## HRSDS SEWAGE DETENTION FACILITY JSP19-10

Public hearing at the request of Oakland County Water Resources Commission and City of Novi for Planning Commission’s approval of Preliminary Site Plan, Wetland Permit, Woodland Permit and Stormwater Management Plan. The subject property is currently zoned I-1, Light Industrial and is located in Section 35, east of Novi Road and south of Nine Mile Road, in the City’s Rotary Park. The applicant is proposing to construct an underground sewage detention facility, associated pump house and emergency back-up generator. The project would also include improvement of the non-motorized trail.

Re: HRSDS Sewage Detention Facility (JSP19-0010)  
 Wetland Review of the Preliminary & Final Site Plan (PSP19-0059)

Re: HRSDS Sewage Detention Facility (JSP19-0010)  
Woodland Review of the Preliminary & Final Site Plan (PSP19-0059)

PROPOSED SITE PLAN WALKWAY PATH AND GRADING

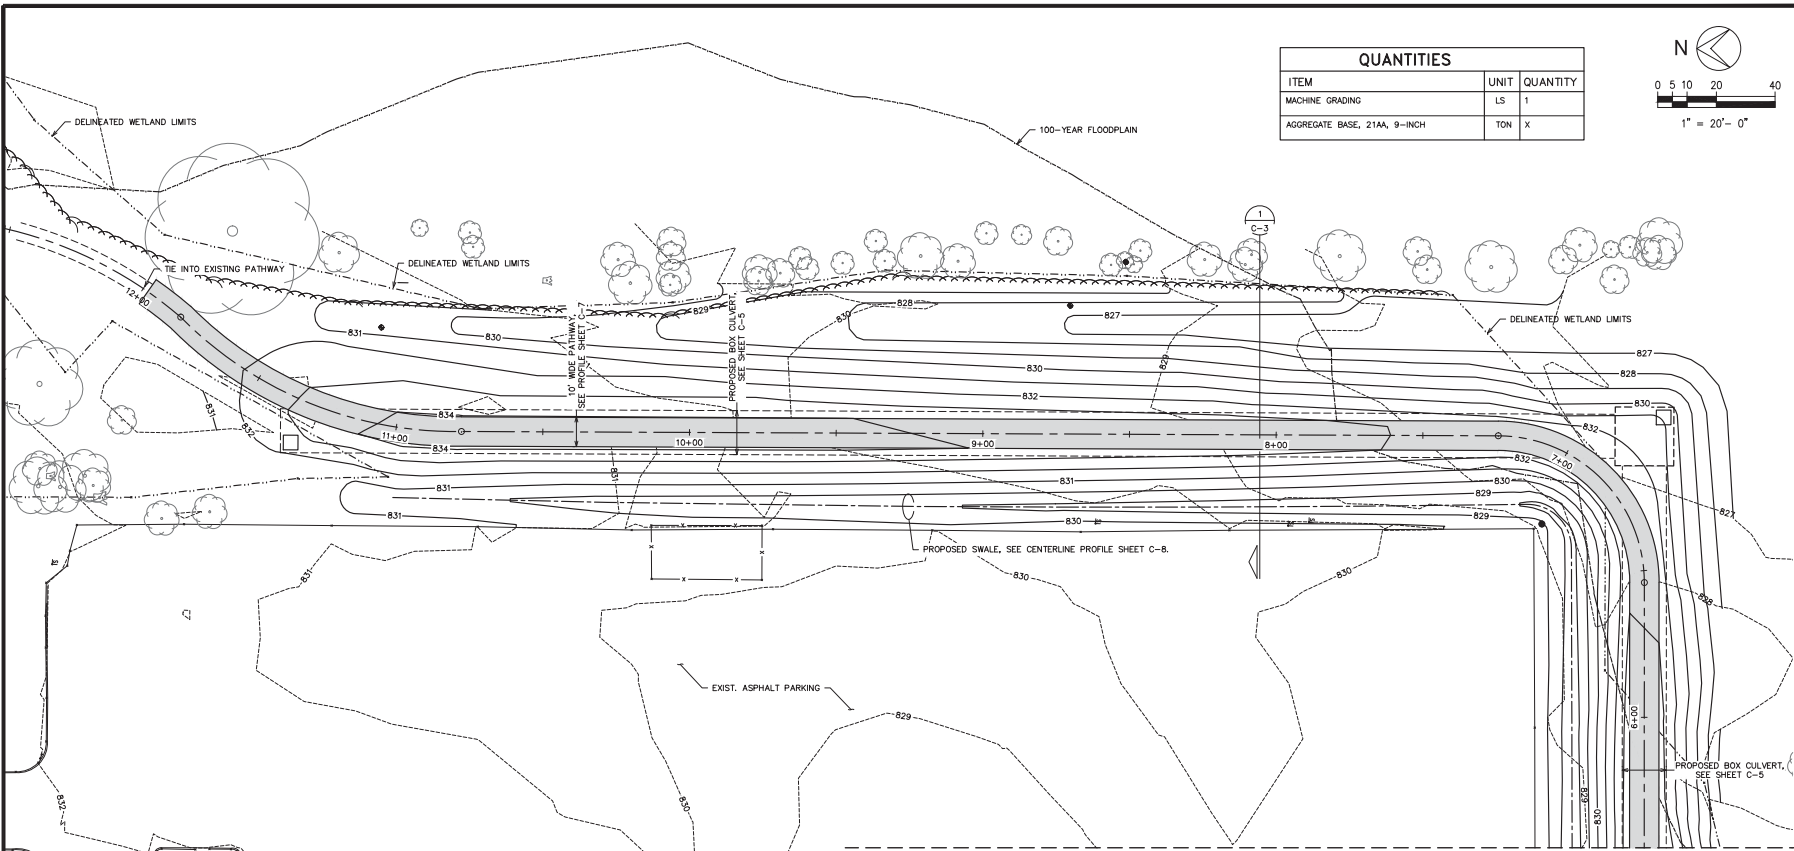
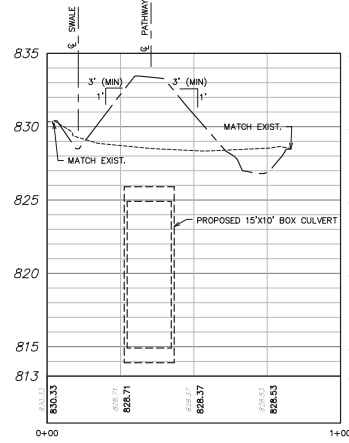
6. Please clearly indicate and label proposed tree protection fencing on Sheets C-3 and L-1, L-2 and L-3.
7. The Plan indicated the 'Disruption/Restoration' limits on the Landscape Plan. The Plan currently notes that a 'City of Novi Modified Pollinator Mix' will be used. Please provide seed mix details on the Plan. In addition, the area to receive the seed mix should be clear on the Plan. Please consider hatching the area to be seeded on the Plan. Woodland replacement credits can be taken for at least some of the native seeding (1 Woodland Replacement Credit for 70 square yards of native-seeded area).
